SAN FRANCISCO PLANNING DEPARTMENT

Certificate of Appropriateness Case Report

Filing Date: February 28, 2013
Case No.: **2011.0913A**
Project Address: **320 Judah Street**
Historic Landmark: Landmark No. 265: The Doelger Building
Zoning: Inner Sunset NCD (Neighborhood Commercial District)
40-X Height and Bulk District
Block/Lot: 1763/ 020 and 021
Applicant: Geoffrey Darby
26 Blue Grass
Irvine, CA 92603
Staff Contact Shelley Caltagirone - (415) 558-6625
shelley.caltagirone@sfgov.org
Reviewed By Tim Frye – (415) 575-6822
tim.frye@sfgov.org

1 SECTION THRU LOBBY
SCALE: 1/2" = 1'-0"

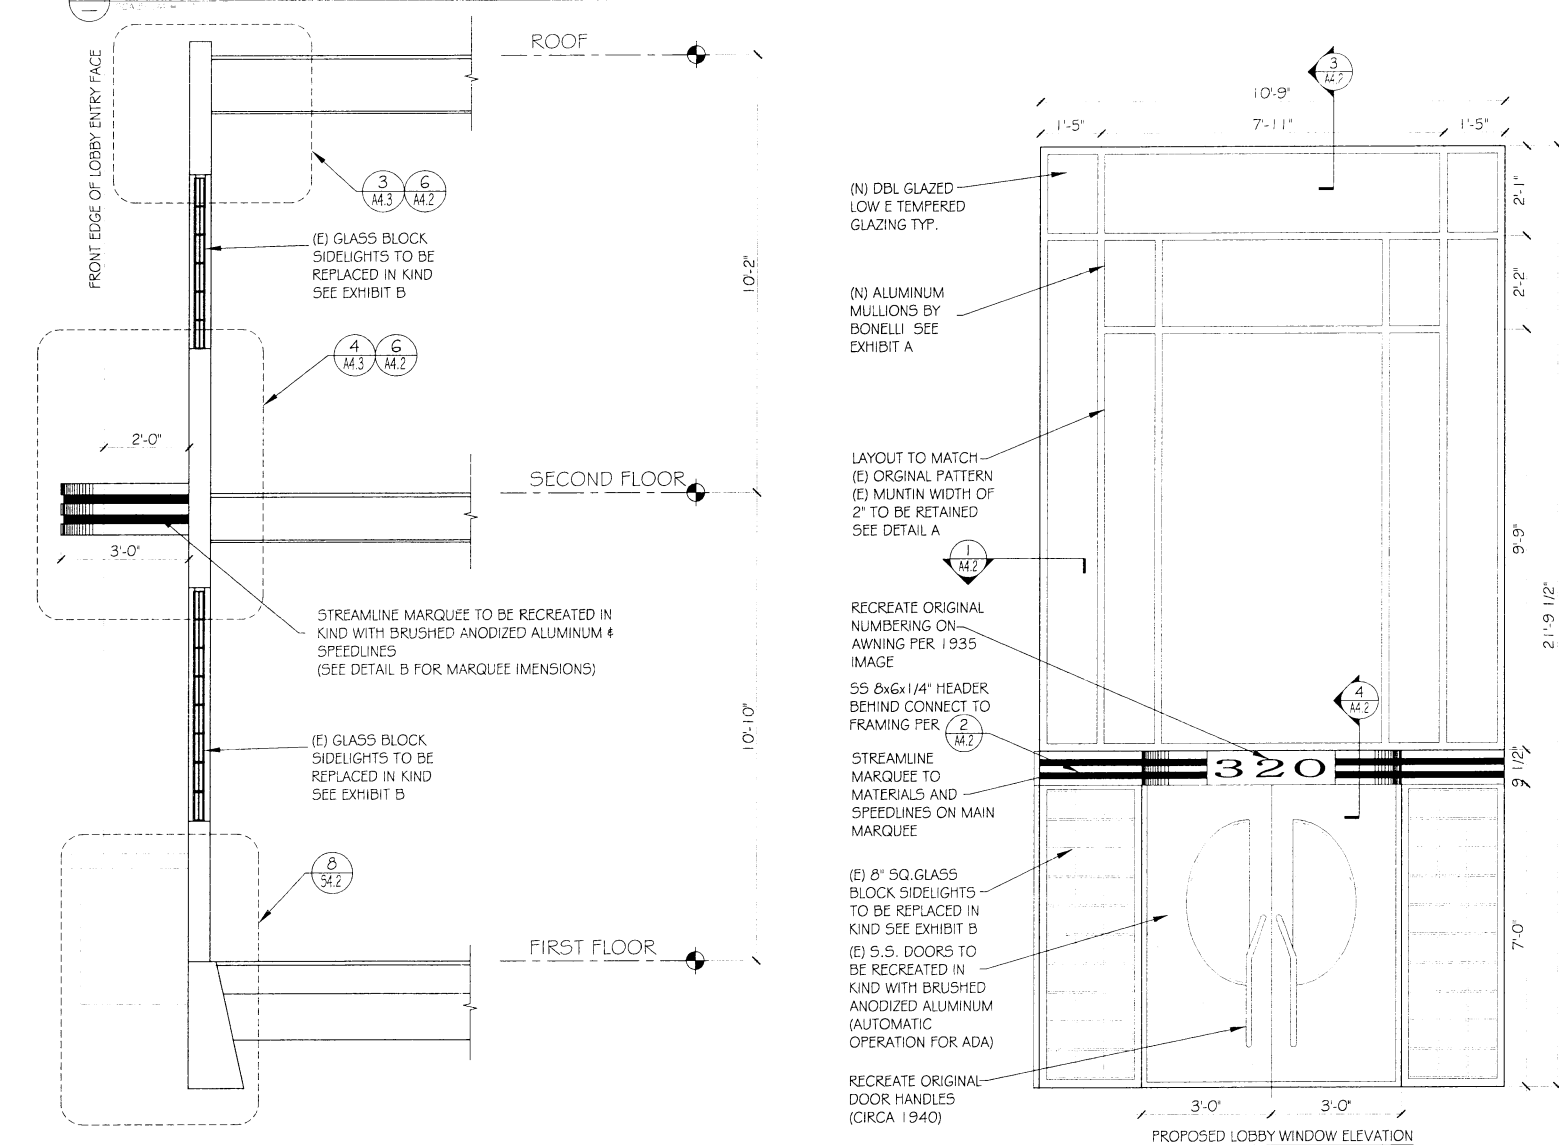
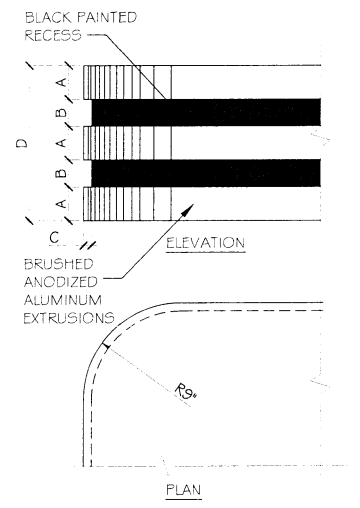
AMEND PER PLANNER'S REQUEST	07-30-13
AMEND PER PLANNER'S REQUEST	05-08-13

KEY PLAN

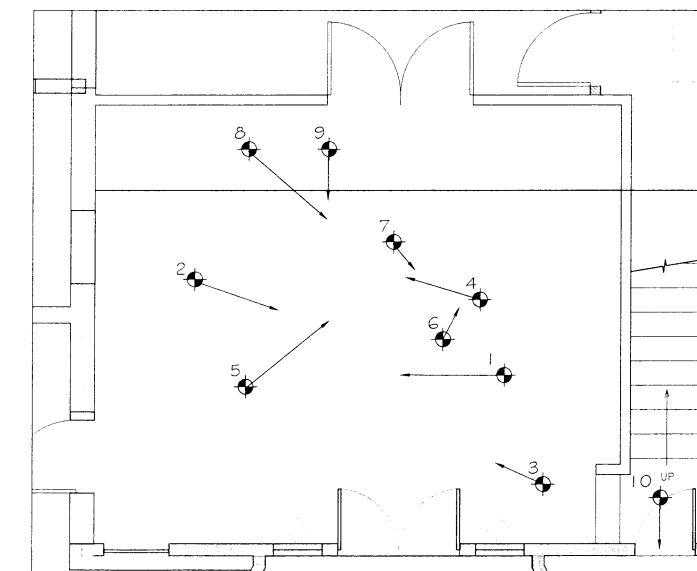
ADDED PER PLANNER'S REQUEST 07-30-13
